**ADDENDUM  
NO. 3**

**September 30, 2025**

**VALE FACILITY ADDITION/RENOVATIONS AND  
MAINTENANCE/IT FACILITY PROJECTS**

**Addendum Three (AD.03)** to the drawings and specifications prepared by Gibraltar Design for **Valparaiso Vale Facility Addition/Renovations and Maintenance/It Facility and Related Work** for Valparaiso Community Schools, Valparaiso, Indiana.

**2 FOUNDATION SECTION - ALTERNATE RAMP**  
3/4" = 1'-0"

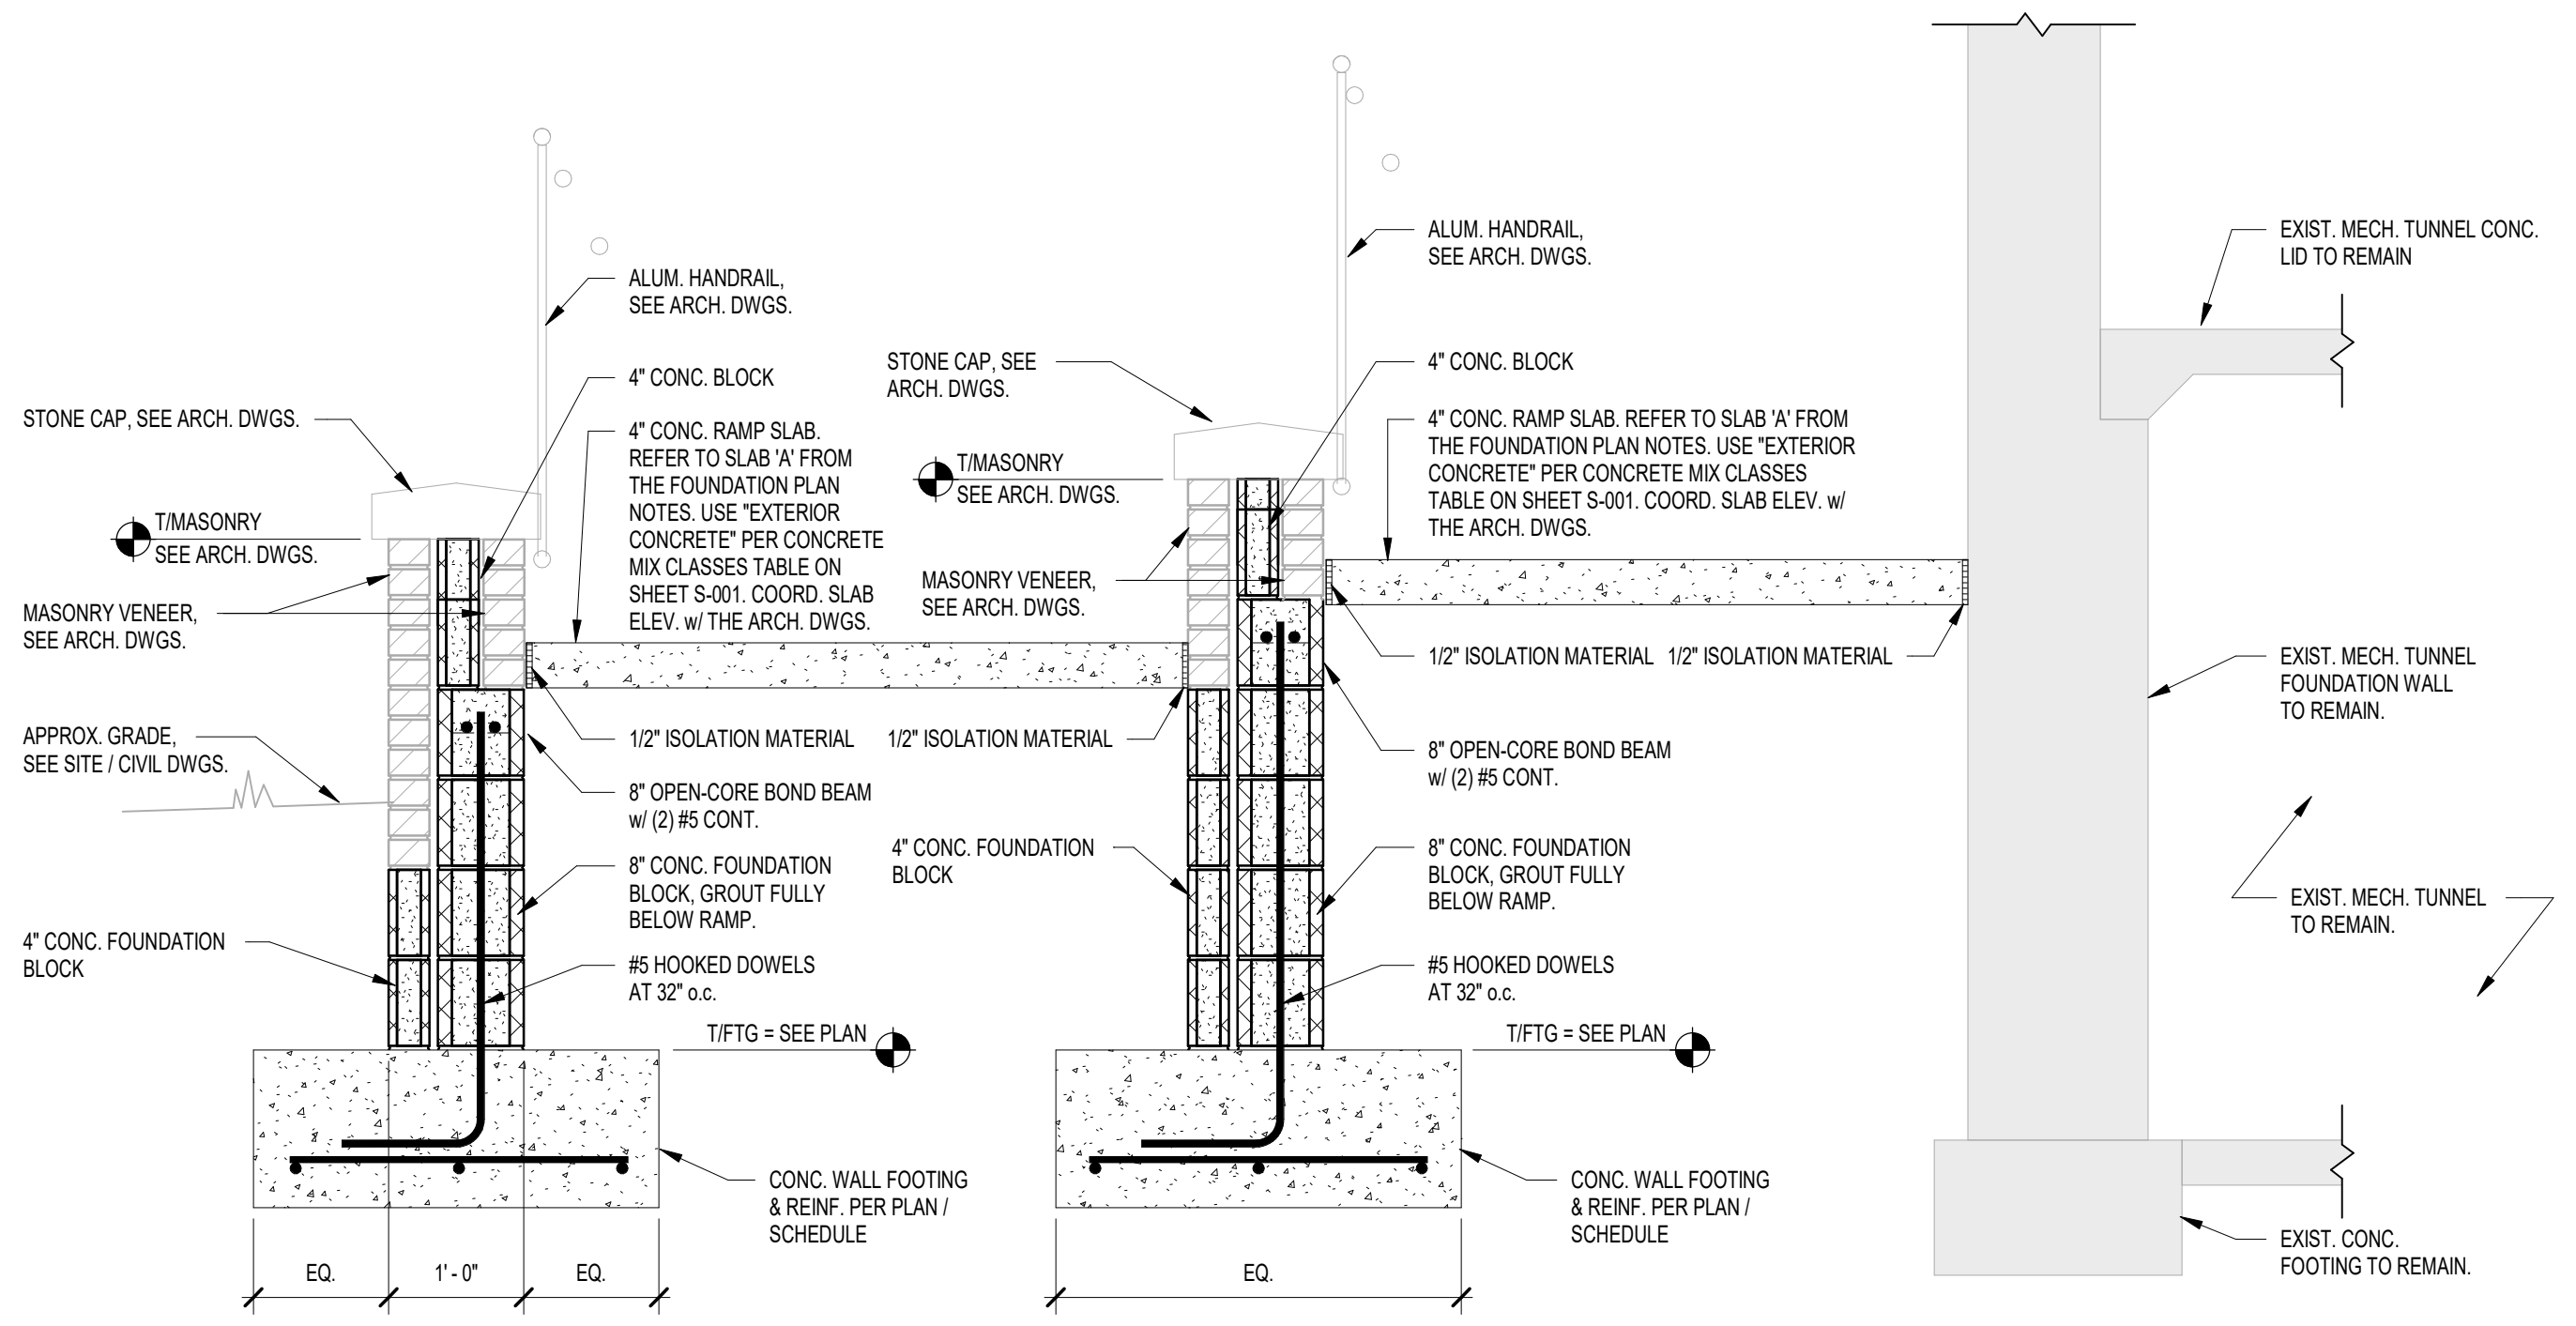
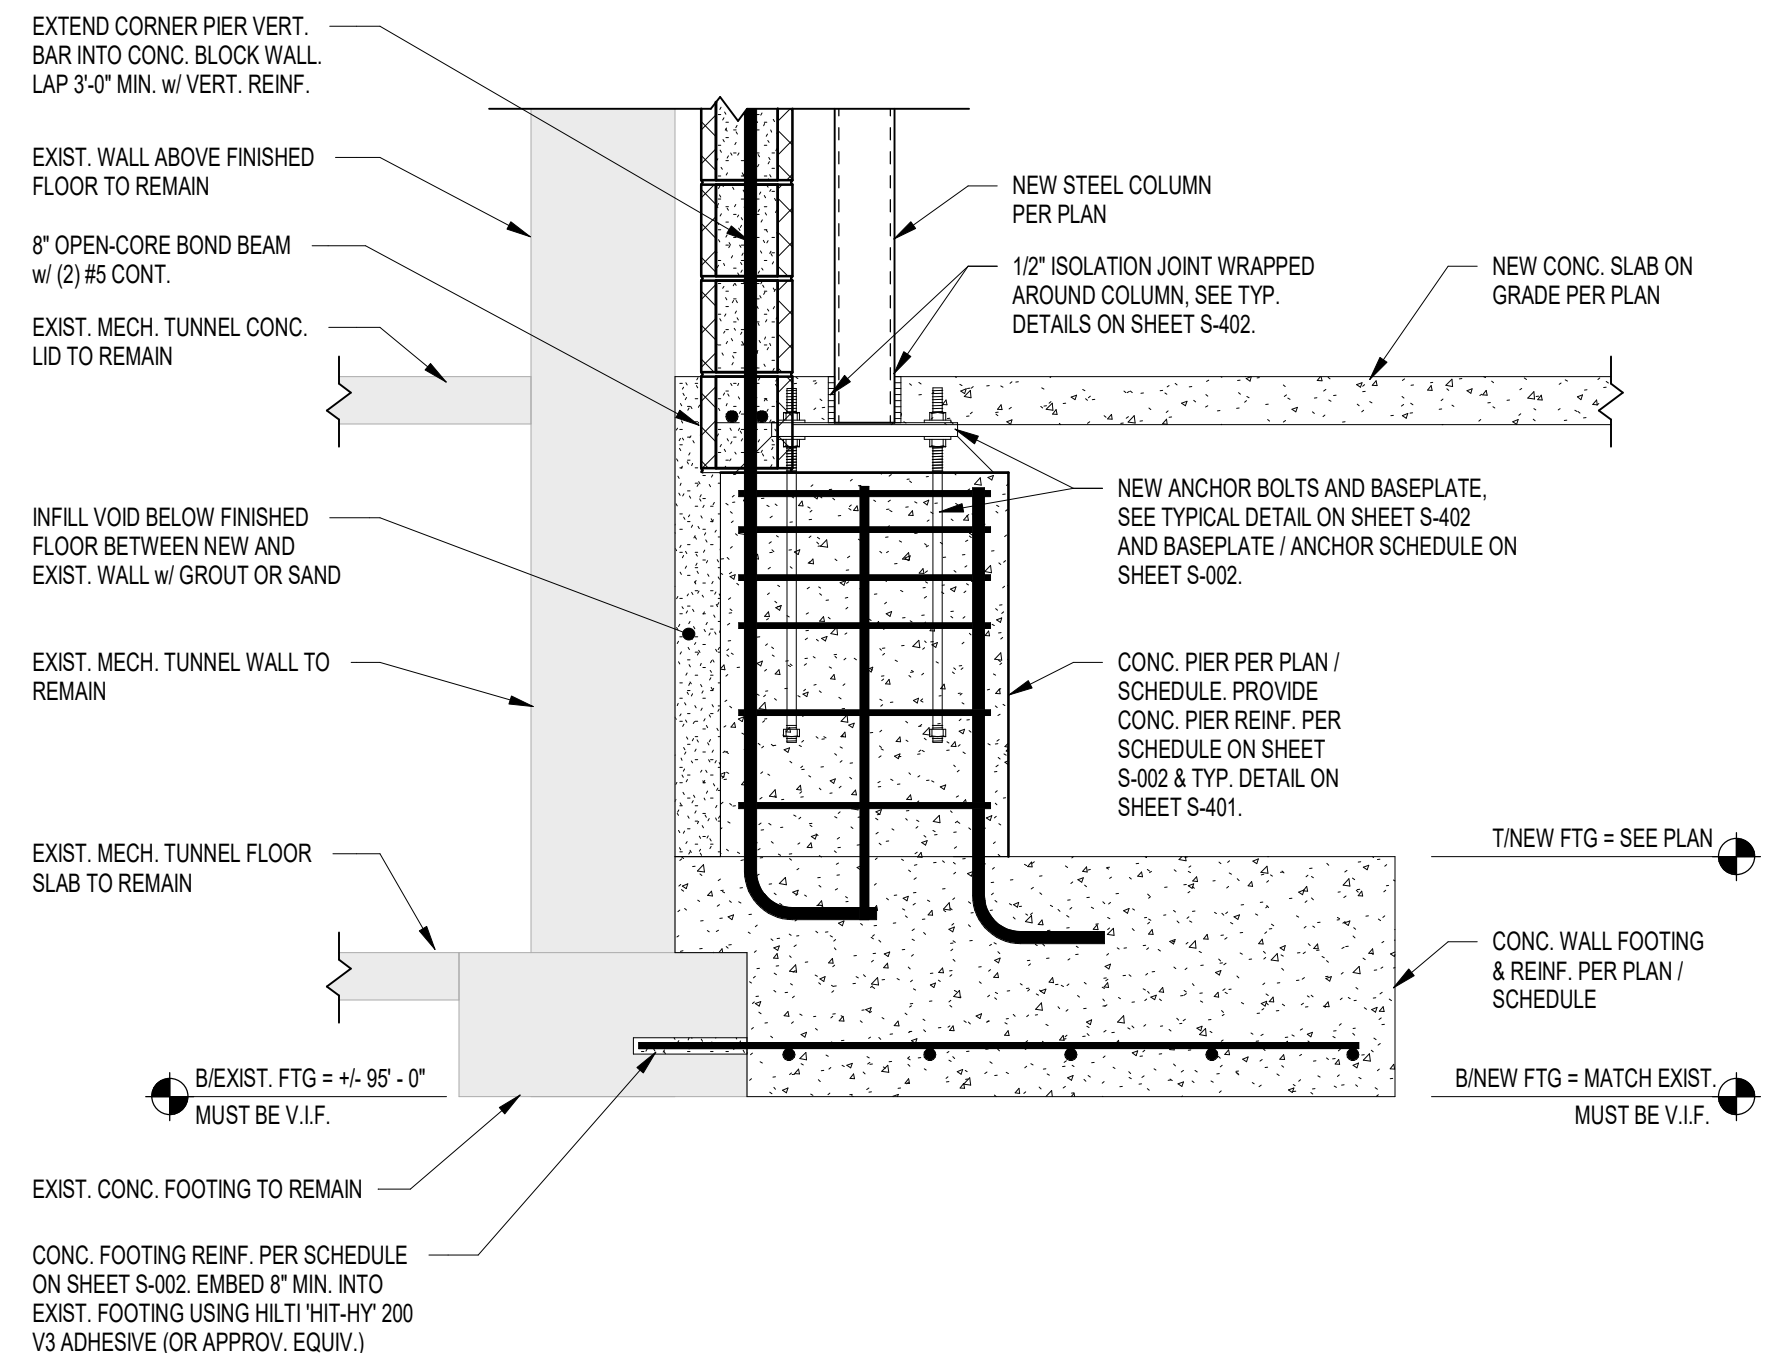
- A. Sheet S-404 has been added to the construction documents this Addendum.

GIBALTAR DESIGN SHEET  
**B AD102**

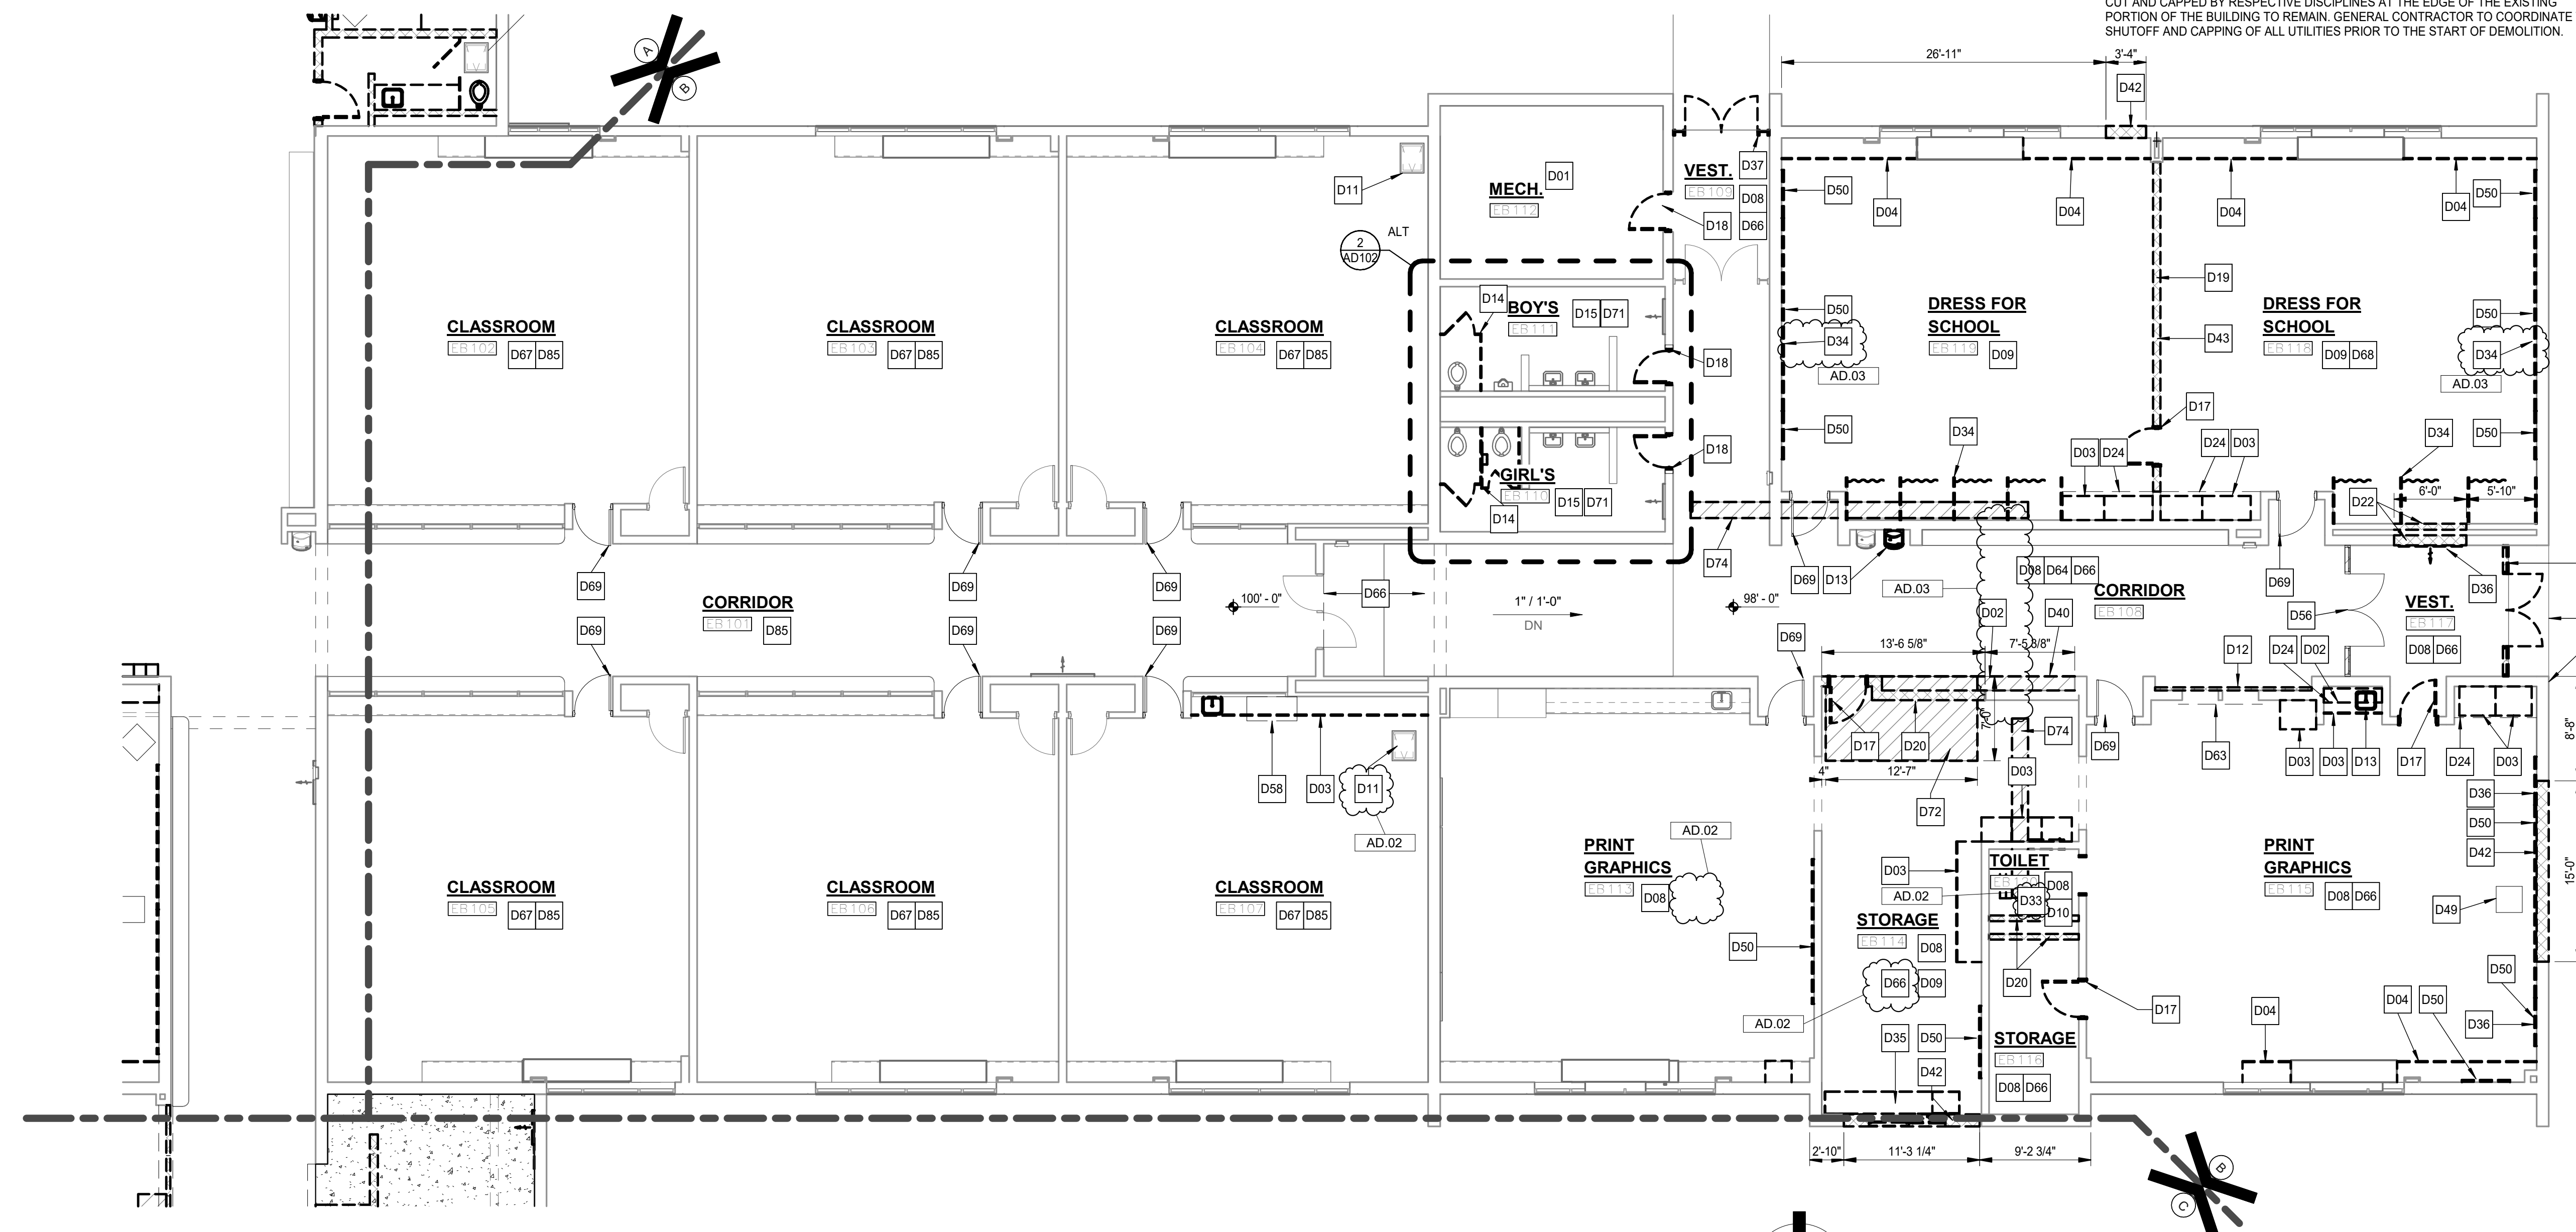
- A. Refer to revised, full-size drawing, included in this Addendum, for revisions.
  1. Reduced saw cutting in corridor EB108.
  2. Added Keynote D02 in room EB115.
  3. Added Keynote D34 in room EB118 and EB119.
